**SUBJECT:** Transmittal of Revised Responses to AP1000 DSER Open Items

**AP1000 Design Certification Review  
Draft Safety Evaluation Report Open Item Non-Proprietary Responses**

DSER Open Item Number: 21.5-1 Item ADS4 K Sensitivity

Original RAI Number(s): 440.164

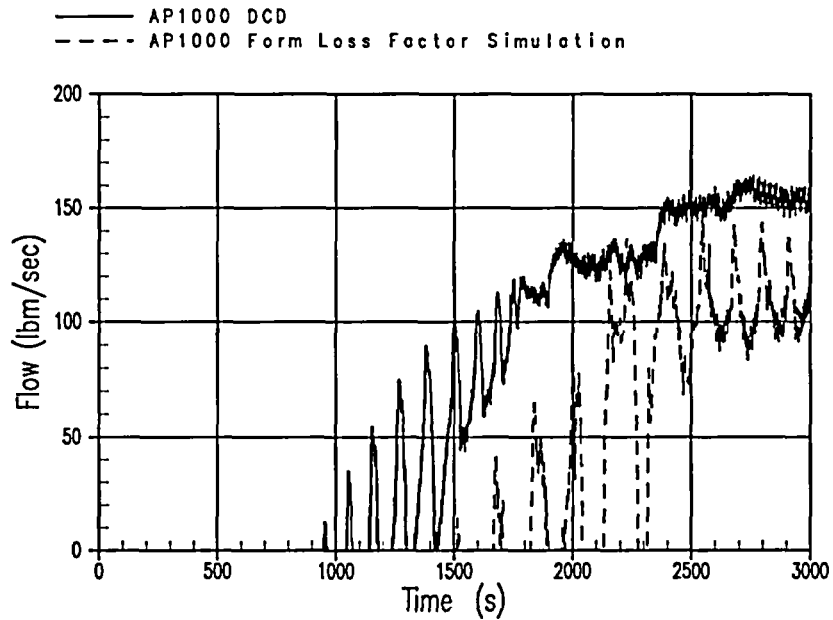
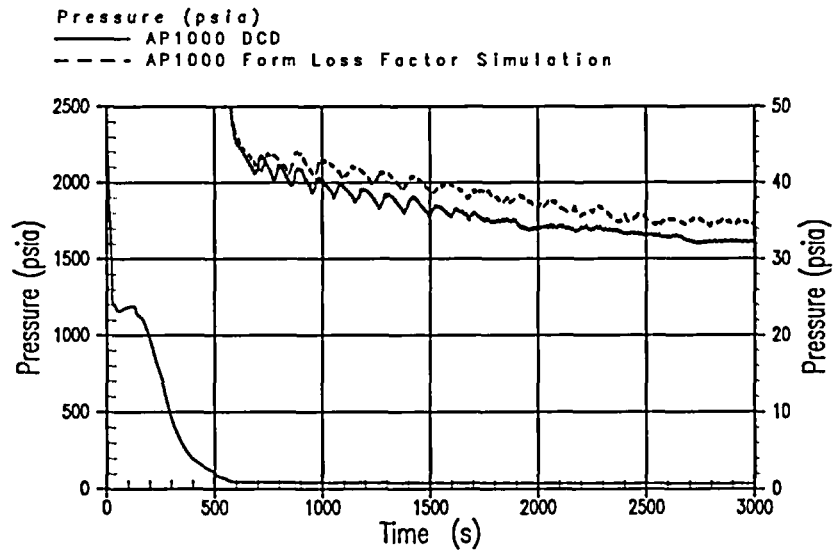
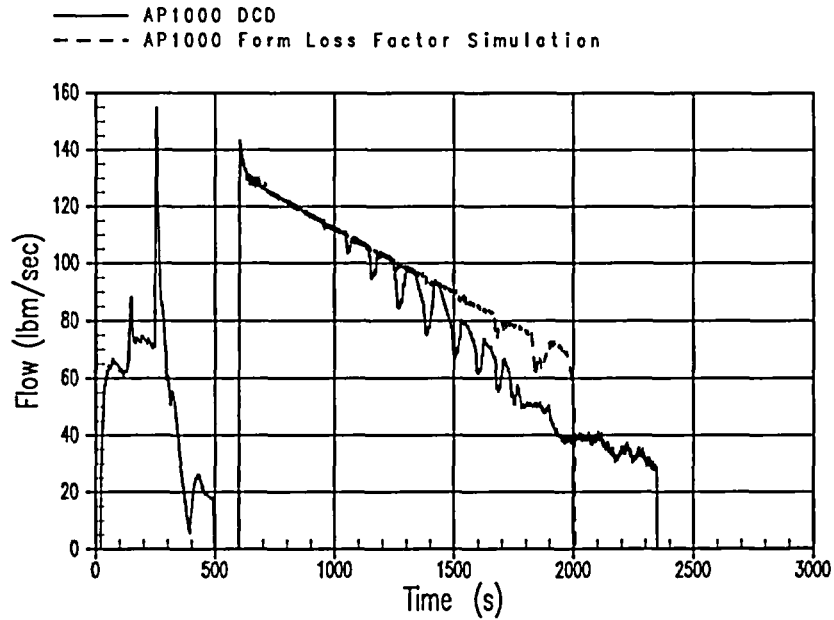
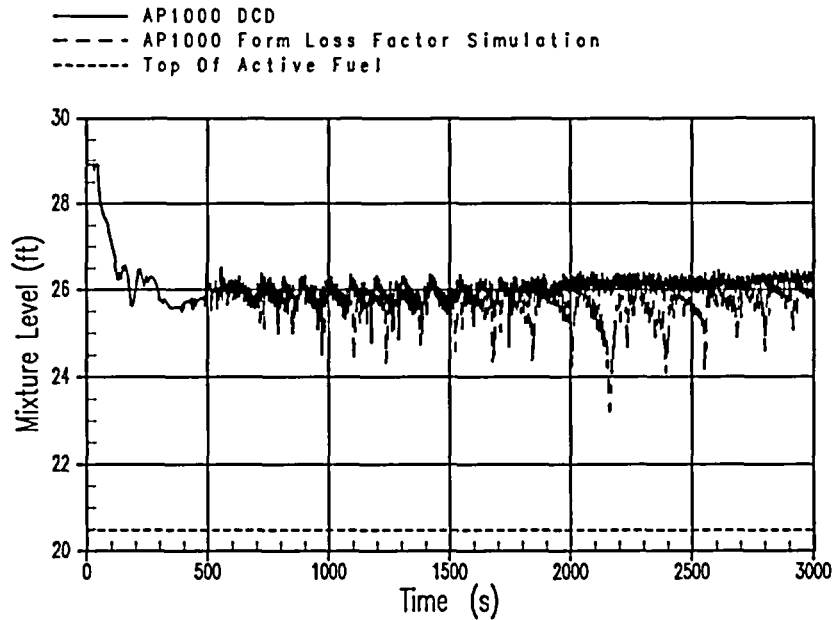
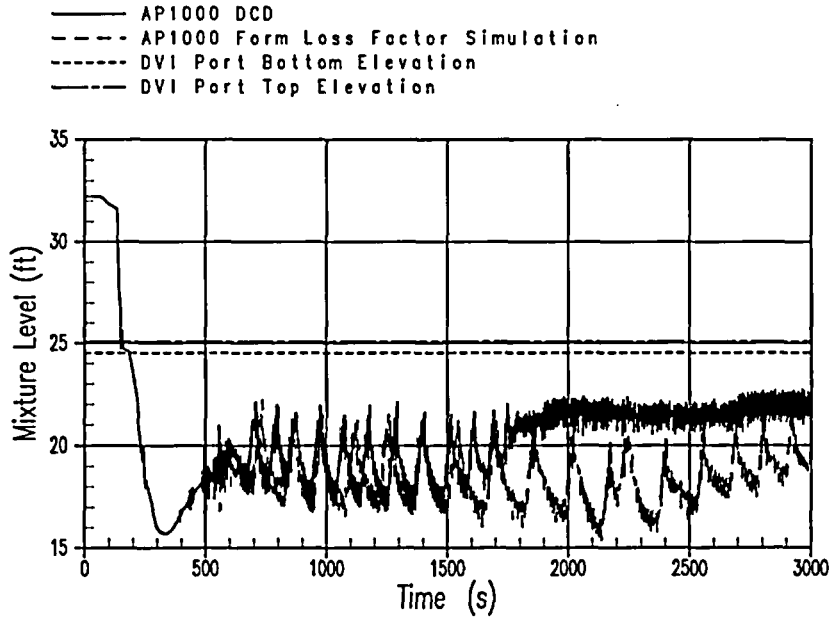
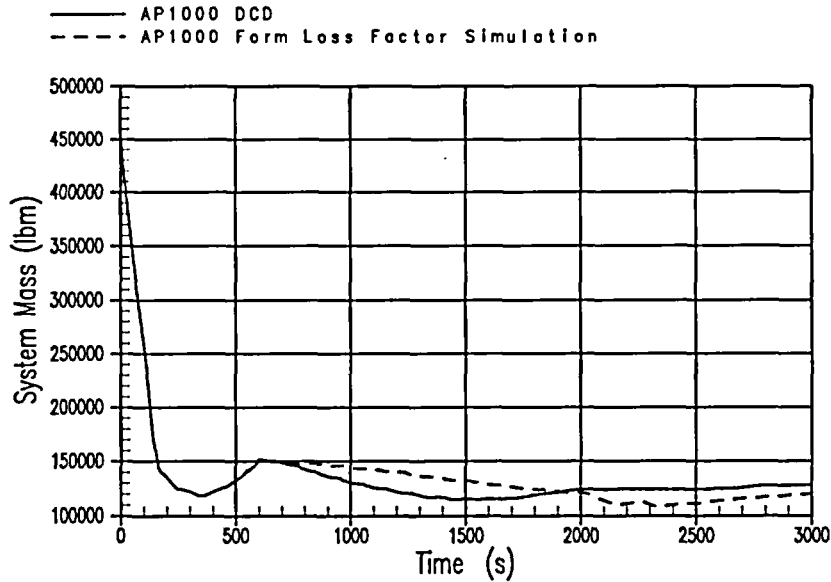
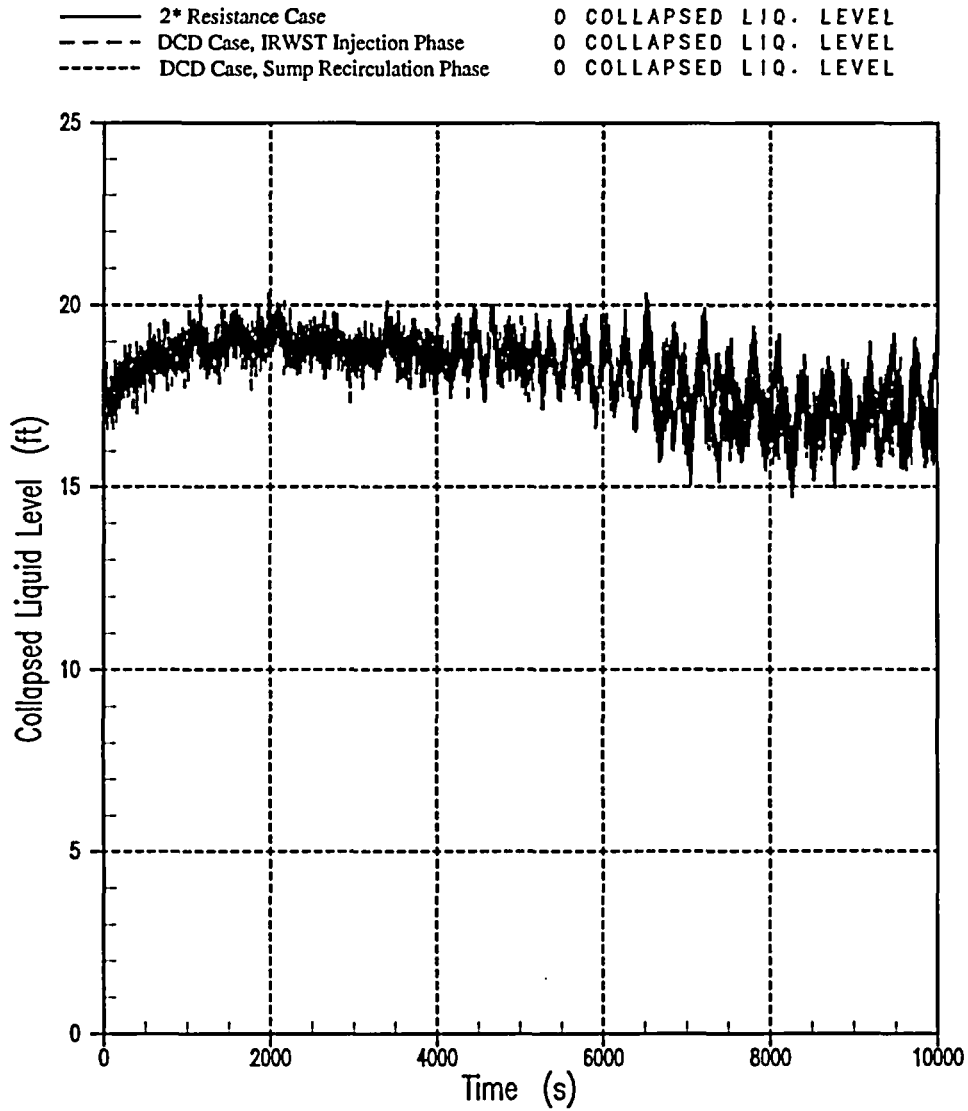
In the October 2, 2003, NRC / Westinghouse meeting on AP1000 thermal/hydraulic open items the NRC requested NOTRUMP (SBLOCA) and WCOBRA/TRAC (LTC) sensitivity analyses to the form loss factors used in modeling the AP1000 ADS4 flow paths.

The NOTRUMP DEDVI, with the adjusted ADS-4 flow paths, simulation was performed in the same fashion as the DCD cases. The event times for this transient are shown in Table-1. The transient results are shown in Figures 1 through 7 for the base DCD case and for the

sensitivity case. The results indicate that the increased ADS4 resistance slows the system depressurization after ADS4 opens and delays the start of IRWST injection. The IRWST is delayed until after the intact CMT has drained. The inner vessel mixture level reaches its minimum just prior to sustained IRWST injection for the sensitivity case but is still well above the top of the core.

The base DCD analysis includes conservatism in the ADS4 form losses in the method used to determine these losses for the ADS4 flow paths. This sensitivity analysis indicates that the DCD analysis is not highly sensitive to the ADS4 flow path form losses.
